MEMORANDUM

DATE: 20 September 2023
TO: Development Determination Panel (DDP)
CC: Adam Richardson, Manager Development Assessment
FROM: Brittany Harrison
SUBJECT: Item 3.8, DA2023/0123 - 9 Lincoln Avenue, Collaroy

(Figure 1: Western envelope encroachment - red shading proposed, blue shading existing).

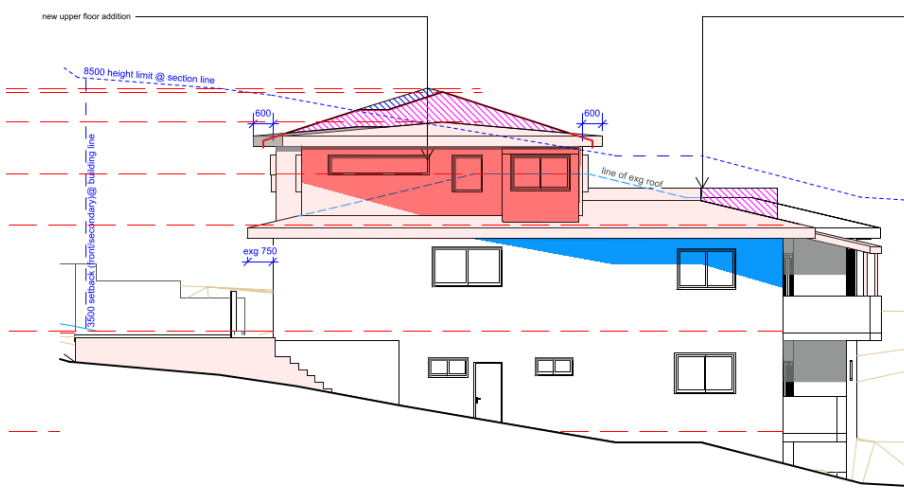
The amended plans have failed to address the side building envelope non-compliance of 82.5% on the western envelope, as the upper floor addition has not been amended to increase side setbacks and reduce the overall floor space area. This issue with the proposed development has been apparent since the issue of the Request for Further Information Letter dated 28 April 2023. The encroachment extends the entire length of the upper floor along the western elevation which will amalgamate with the

non-compliant building envelope of the existing dwelling, further exacerbating the extent of non-compliance. It is again acknowledged that the building height has been reduced, however, the extent of building bulk and spatial separation between properties has not been amended. As such, the amended plans still show that the upper floor addition in its current form is an over development of the site, resulting in a dwelling house that is visually dominant by virtue of its height and bulk and provides for minimal articulation.

It is concluded that the proposed building envelope is still inconsistent with the aims and objectives of the control.
